# UNITED STATES PATENT AND TRADEMARK OFFICE

APPLICATION NO.	FILING DATE	FIRST NAMED INVENTOR	ATTORNEY DOCKET NO.	CONFIRMATION NO.
10/771,603	02/04/2004	Sung-Bum Park	5000-1-511	3429
33942	7590	08/01/2007		
CHA & REITER, LLC 210 ROUTE 4 EAST STE 103 PARAMUS, NJ 07652			EXAMINER LIU, LI	
			ART UNIT 2613	PAPER NUMBER
			MAIL DATE 08/01/2007	DELIVERY MODE PAPER

<b>Office Action Summary</b>	<b>Application No.</b> 10/771,603	<b>Applicant(s)</b> PARK ET AL.	
	<b>Examiner</b> Li Liu	<b>Art Unit</b> 2613

## **DETAILED ACTION**

Fig. 5(b)

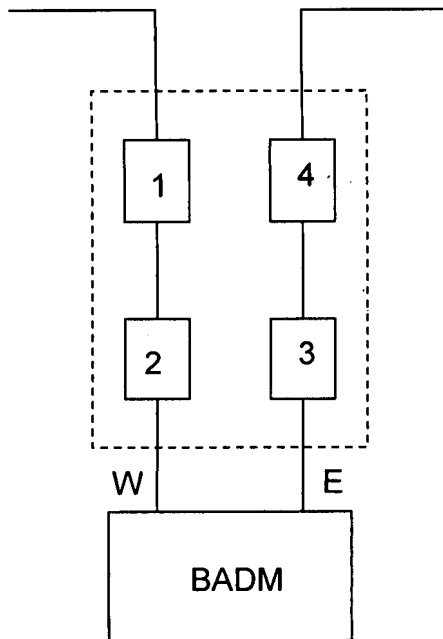
With regard to item (B), the applicant actually uses a "cross/bar" switch. The Figures 5(b) and 5(c) of applicant can be plotted as:

The cross/bar switch is well known and widely used in the art. Oberg et al teaches a bidirectional add/drop multiplexer and uses a cross-bar switch (Figures 4, 6-12) for performing a switching operation to connect a first port to a second port and a third port to a fourth port in case of a normal state and to connect the first port to the third port and the second port to the fourth port in case of system failure so that the optical signal having higher priority can be recovered first (Oberg et al: ABSTRACT; [0070]-[0073]).

But, in Oberg's system, the cross-bar switch is connected to the one fiber line via the add/drop filter 27w and 27e, the switch is not directly connected to the one fiber line.

However, where the switch is putted is just a design choice, as long as the switch can perform the operation so that the network is self-healing and the optical signal having higher priority can be recovered first.
